# Technical Service Bulletin

SUBJECT:		No: <b>TSB-19-42A-001</b>	
<b>NOISE FROM GAS SPRINGS WHEN OPENING &amp; CLOSING TAILGATE</b>		DATE: <b>March 2019</b>	
		MODEL: <b>See below</b>	
<b>CIRCULATE TO:</b>	<input type="checkbox"/> GENERAL MANAGER	<input checked="" type="checkbox"/> PARTS MANAGER	<input checked="" type="checkbox"/> TECHNICIAN
<input checked="" type="checkbox"/> SERVICE ADVISOR	<input checked="" type="checkbox"/> SERVICE MANAGER	<input checked="" type="checkbox"/> WARRANTY PROCESSOR	<input type="checkbox"/> SALES MANAGER

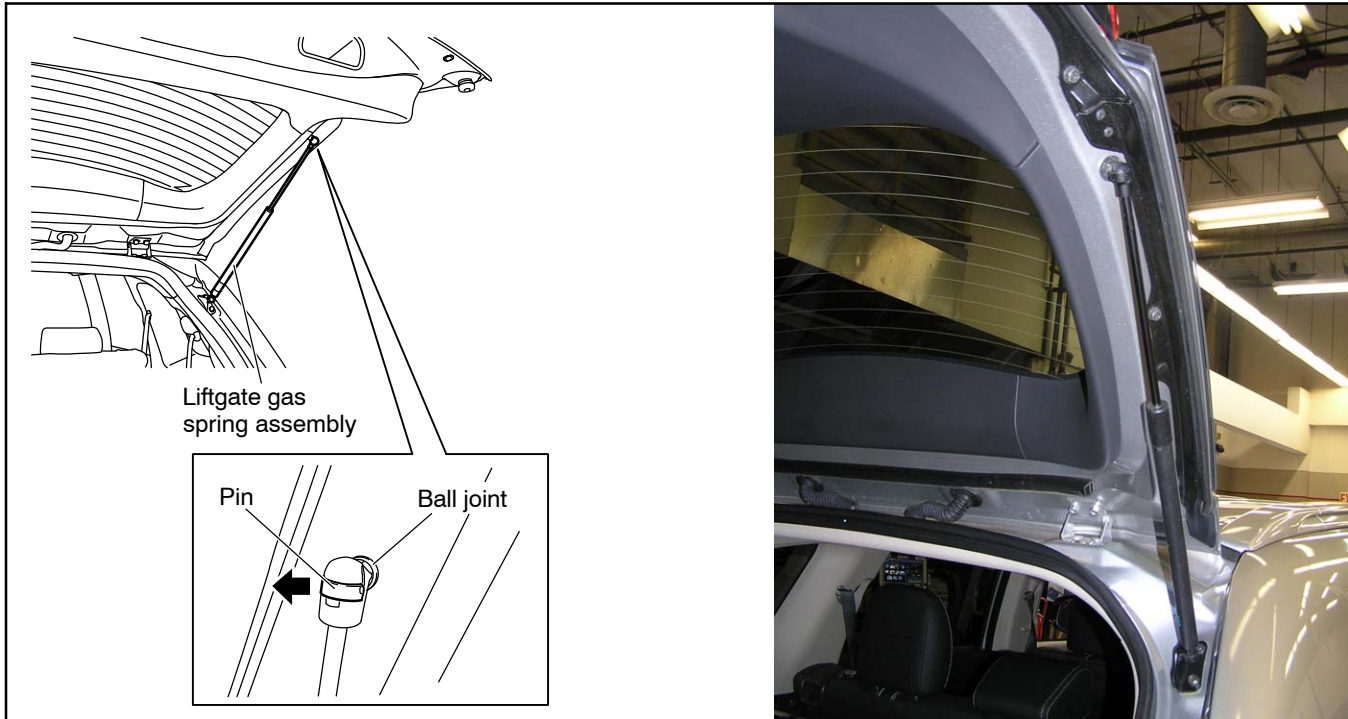
1. Remove BOTH gas springs from the tailgate.

**NOTE: Even if the noise complaint is only for one side, the gas springs for both sides must be replaced at the same time (RH side shown below for example).**

2. Install the **new** gas springs to both sides of the tailgate.
